EOC-Providence VAMC Fire and Fire/Smoke Damper Failed Report

EOC-PROVIDENCE VAMC FIRE AND FIRE/SMOKE DAMPER FAILED REPORT

03/04/15

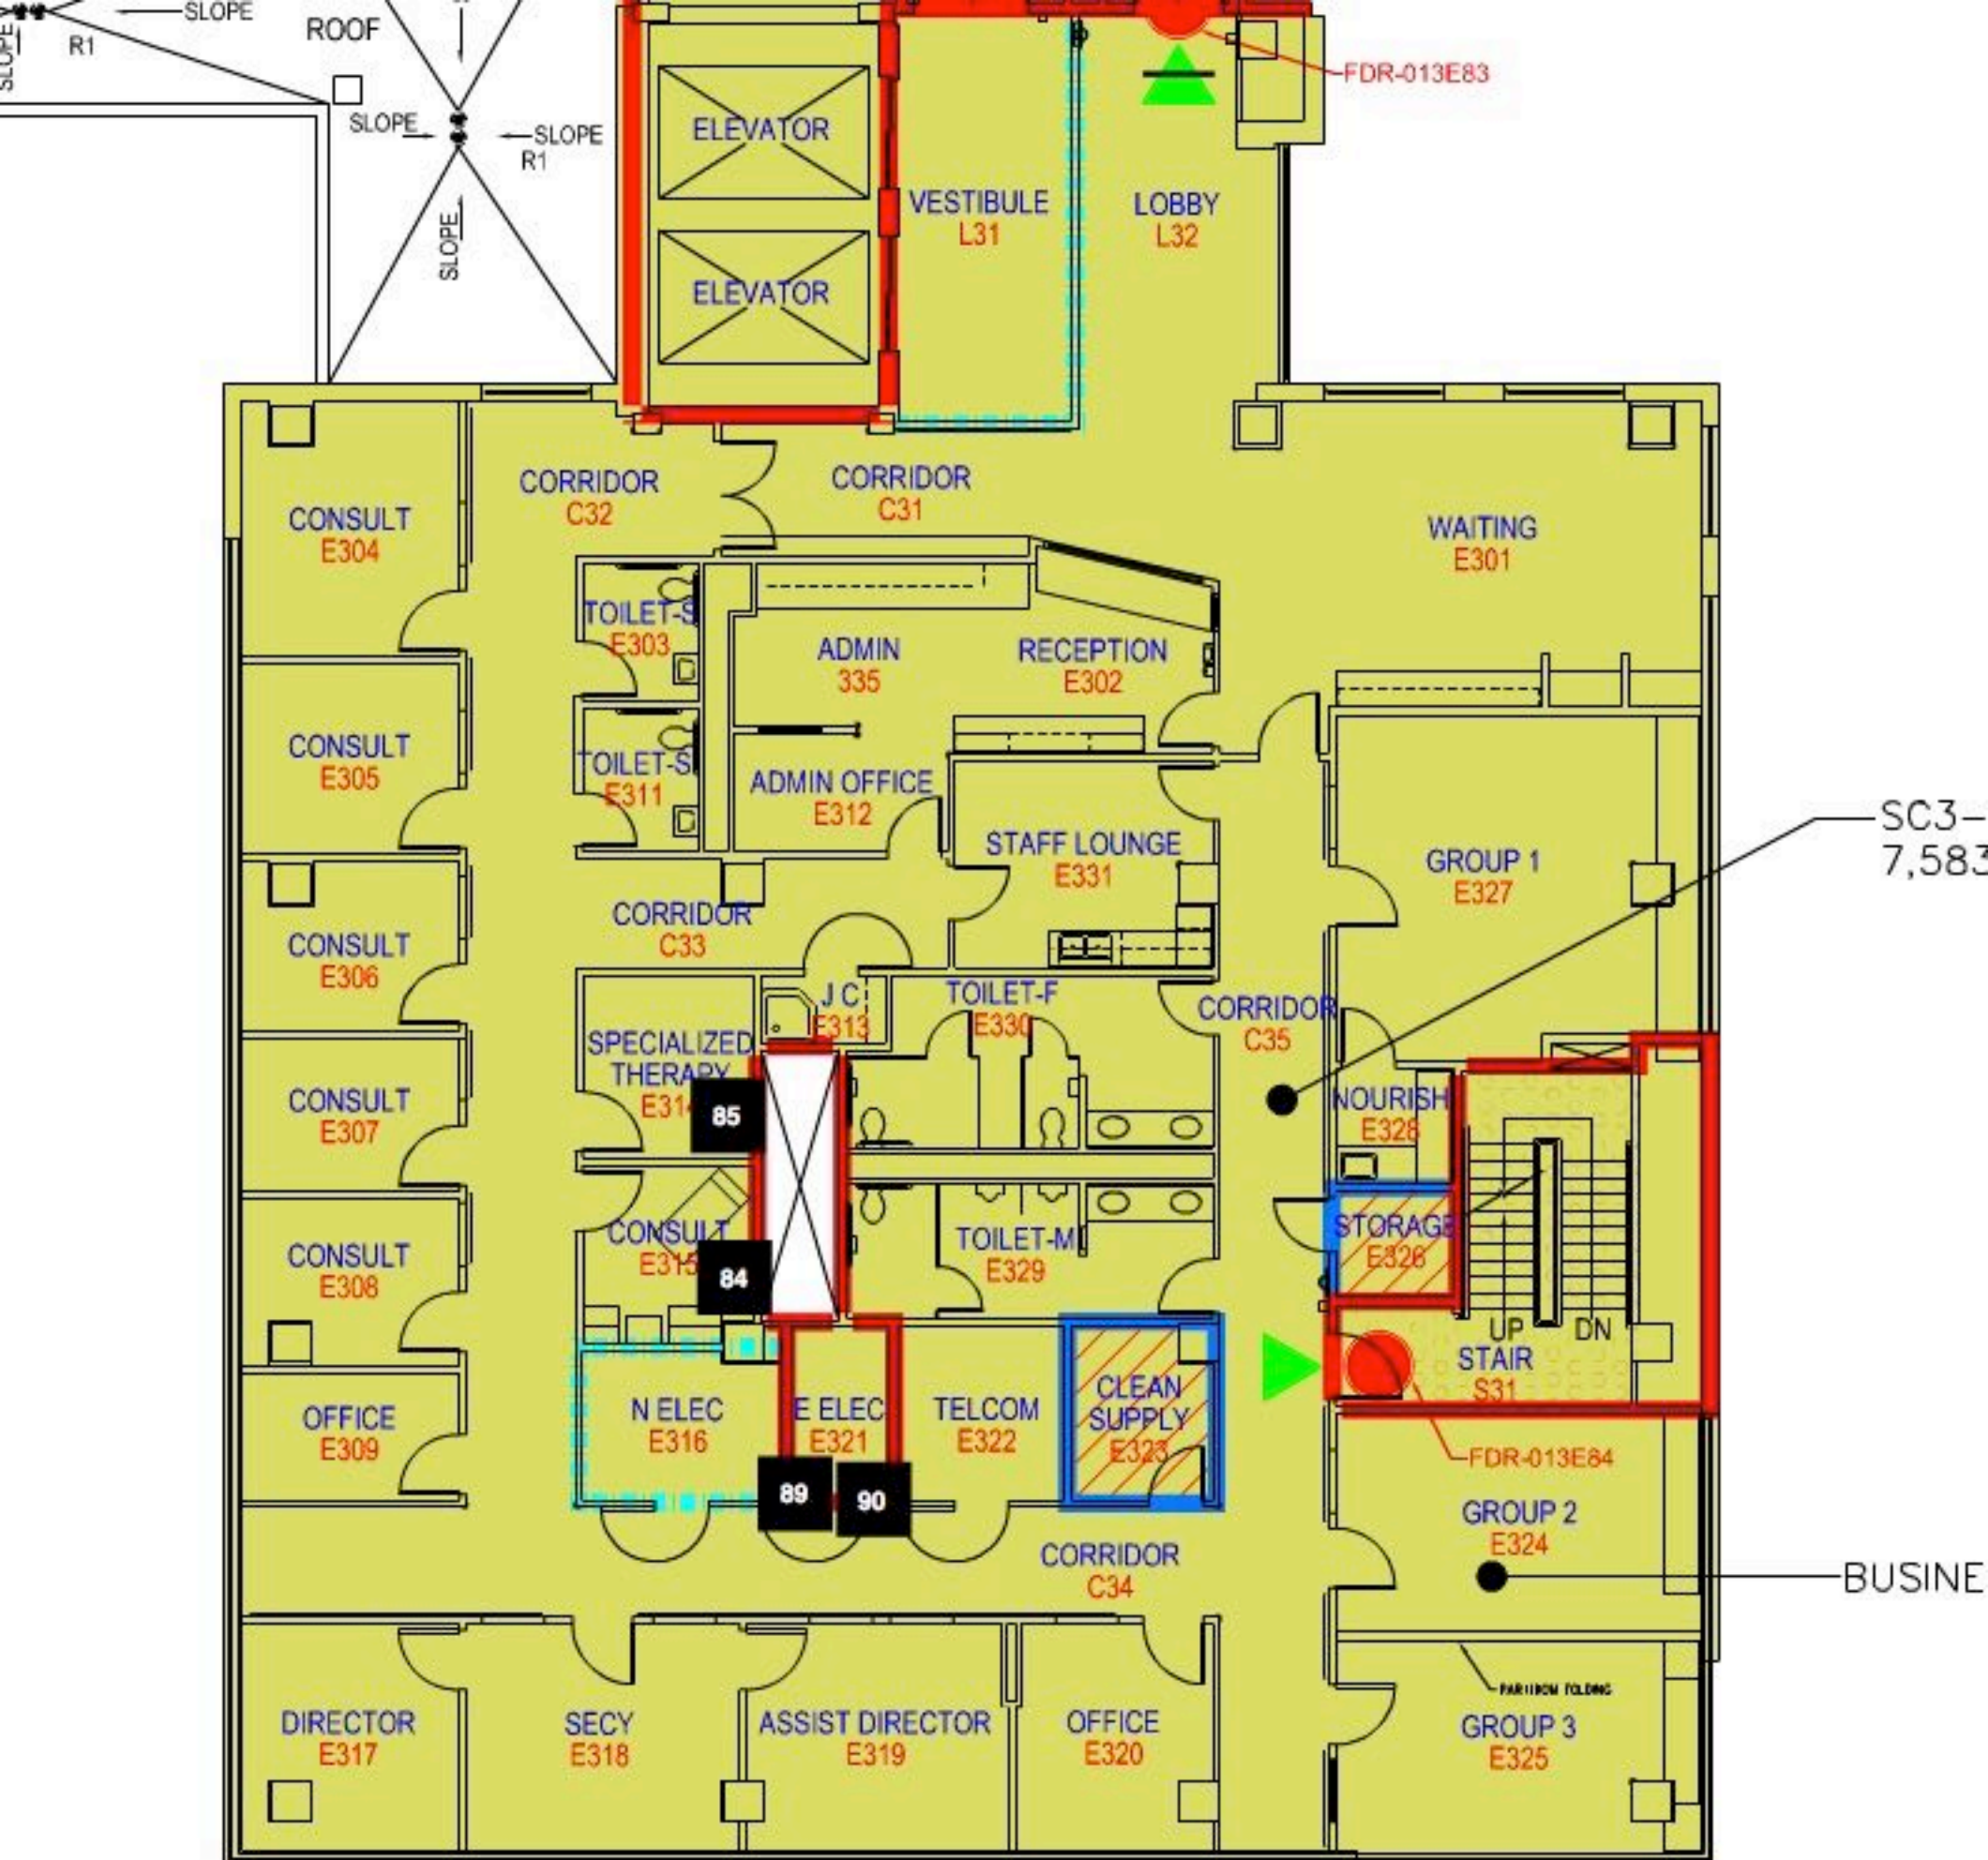
Date Created	Damper Asset Tag #	Damper Size	EOC ID #	Punch #	Type	Floor	Comments
1/13/15	FSD-013E48	30x14	211820	84	Smoke/Fire damper	3rd Floor	Damper Failed. Actuator is functioning properly. No access door was installed to visually test damper.
<div><p>1/13/15 04:45 AM</p></div>

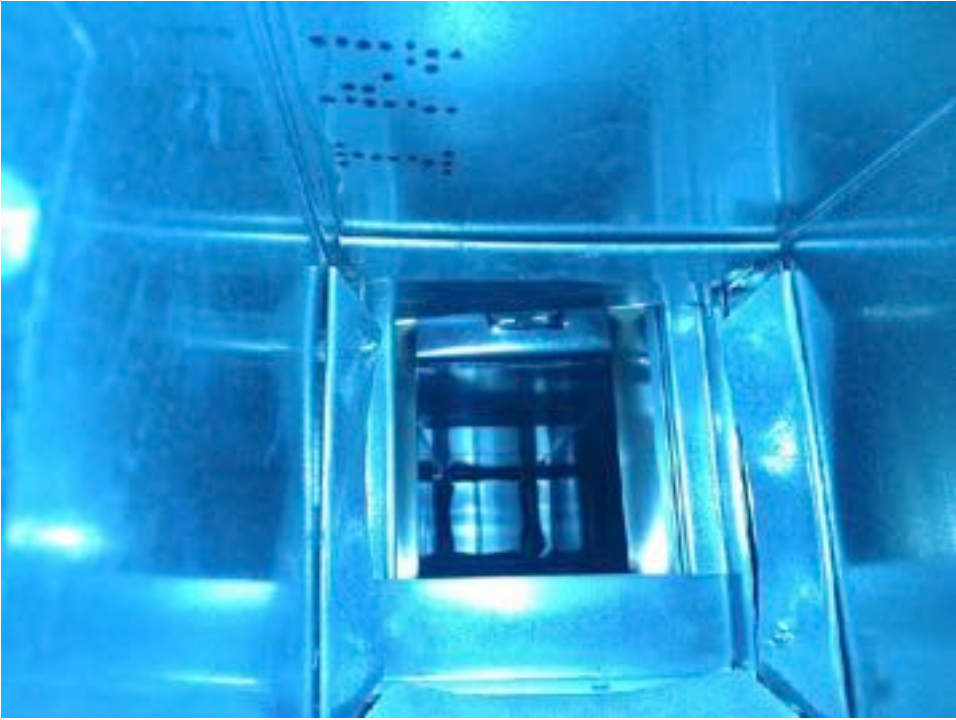
Date Created	Damper Asset Tag #	Damper Size	EOC ID #	Punch #	Type	Floor	Comments
1/13/15	FD-013E169	8x6	211825	39	Fire Damper	3rd Floor	Damper Failed. Damper was damaged during installation and was not installed in the plane of the barrier. Reference: NFPA 80 2013 Section 19.2.1.1.1 A damper installed in a fire resistance-rated assembly shall be located (in its sleeve) within the plane of the fire resistance-rated assembly, unless listed otherwise and installed in accordance with the manufacturer's installation instructions and the listing.
 <p>1/13/15 05:25 AM</p>

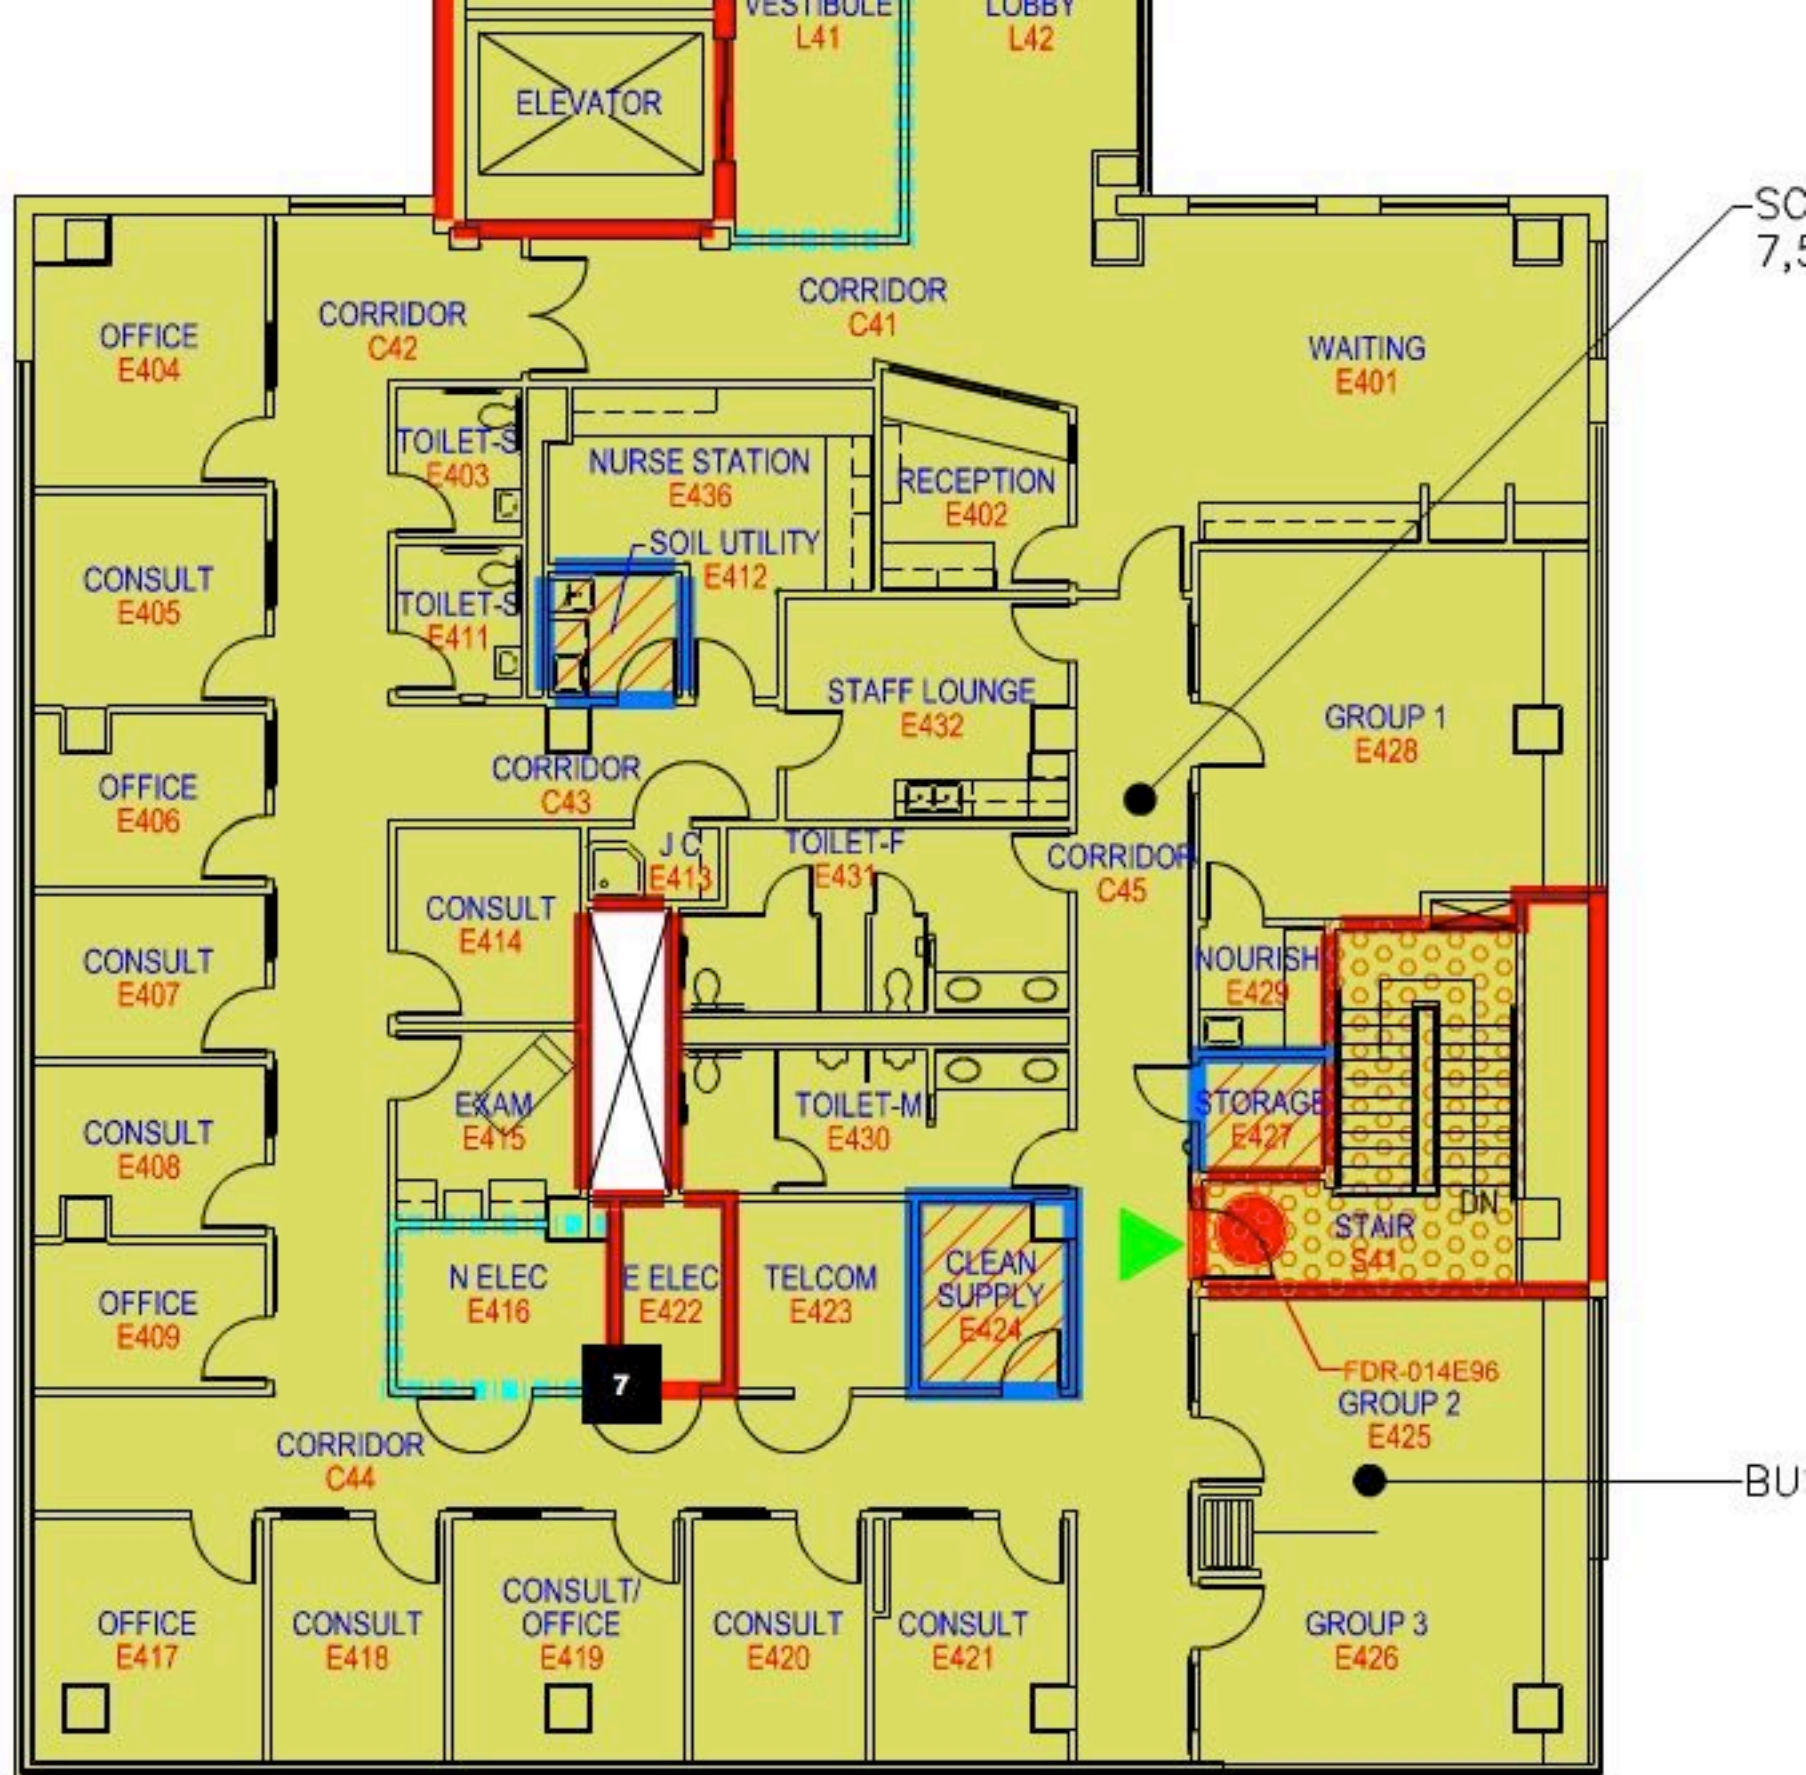
Date Created	Damper Asset Tag #	Damper Size	EOC ID #	Punch #	Type	Floor	Comments
1/13/15	FD-013E168	6x6	211826	90	Fire Damper	3rd Floor	Damper Failed. Damper was damaged during installation and was not installed in the plane of the barrier. Reference: NFPA 80 2013 Section 19.2.1.1.1 A damper installed in a fire resistance-rated assembly shall be located (in its sleeve) within the plane of the fire resistance-rated assembly, unless listed otherwise and installed in accordance with the manufacturer's installation instructions and the listing.
 <p>1/13/15 05:30 AM</p>
